Document Number S22042

Re: Newport - DA2022/2152 - 122 Crescent Road - RFI Responses

Figure: Developed Catchment with Retentions as compared to Detention and slow Drainage Strategies (From ARR2019 Figure 9.4.3)

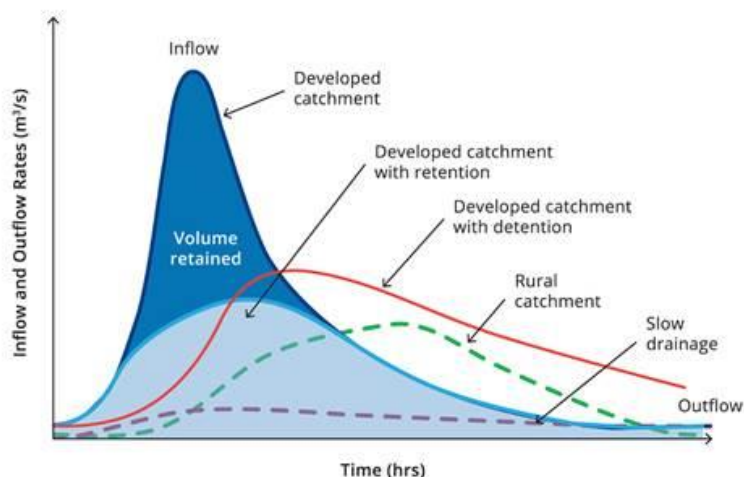
BG&E provides the following letter in response to Northern Beaches Council’s comment on implementing the stormwater management with an OSD tank. The following response encompasses Northern Beaches Council’s Water Management for Development Policy (2021) and Australia’s best practice using the Australian Rainfall & Runoff (2019) requirements:

Chapter 4 of ARR2019 talks about stormwater volume management, where the aim of managing stormwater at catchment wide analysis is to think about the volume of water being moved. Figure shows the impact of implementing different stormwater volume management devices, such as OSD and retention, compared to the undeveloped and unmanaged flows.

The above figure communicates that the idea with the implementation of OSD is to help manage the volume of water in a rain event as to not overwhelm the existing network or to contribute to a larger catchment peak flow event which can lead to flooding event. The major aim is to reduce the peak flow discharge rate and to extend the period out over which stormwater is released into the network.

The main issue with our site being located at the downstream extent of the catchment is if we are required to implement an OSD tank, this would have a significant impedance on the existing council network as it would slow down the discharge rate from our site and align the stormwater discharge from upper catchment.

Thus, it would result in the headwall having to deal with both peak flow rates from the catchment at the same point in time instead of letting them be naturally staggered.

As a result of both council and ARR2019 best practise we are not proposing OSD for DA2022/2152 - 122 Crescent Road
